STAFF REPORT

PLANNING & ZONING COMMISSION

2. COMBINED PRELIMINARY AND FINAL DEVELOPMENT PLAN REVIEW

Request: To review a proposal to construct a dance studio on 1.18 acres.

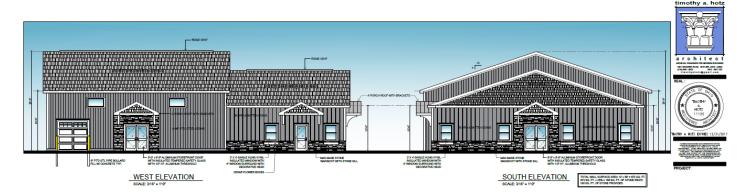
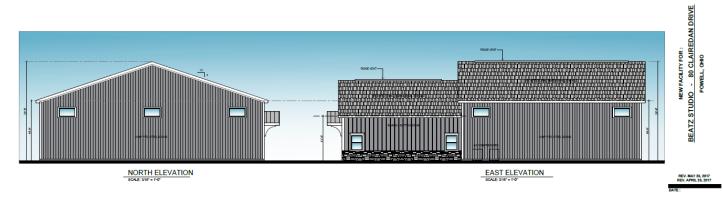
The applicant has made changes to the site plan to update what was discussed at the meeting. A minor change to the site plan, the applicant moved the handicap parking spaces were moved further to the south. The substantial change to this submission is the architecture of the building were changed greatly from the last design.

The applicant met with Staff and the Architectural Advisor to review the new design. At the meeting staff mentioned that the design of the building was much better but that the colors need to be changed to a lighter palette to better blend with the existing buildings in Wolf Commerce Park. The Architectural Advisor made mention that new buildings do not need to be copies of what already exists in an area. Staff agrees with this comment that new buildings should be allowed to have their own personality but would add that new buildings should try to blend in. As stated in the previous staff report, the best colors to choose from would be browns and greys but staff is open to other options. Staff would like to note that a new building does not need to be a replica of the existing buildings in the area but it should not be so drastically different that it contrasts negatively.

Staff is pleased with a new business calling Powell home. The site plan is well designed and so is the building in questions. A change in color will go a long way. Otherwise, staff has no issues with the proposal.

- 1) All Architectural Advisor comments are met.
- 2) All City Engineer's comments are met.
- 3) A new color palette is selected and reviewed by staff.
- 4) In the future, the addition to the building is brought back before P&Z for review.
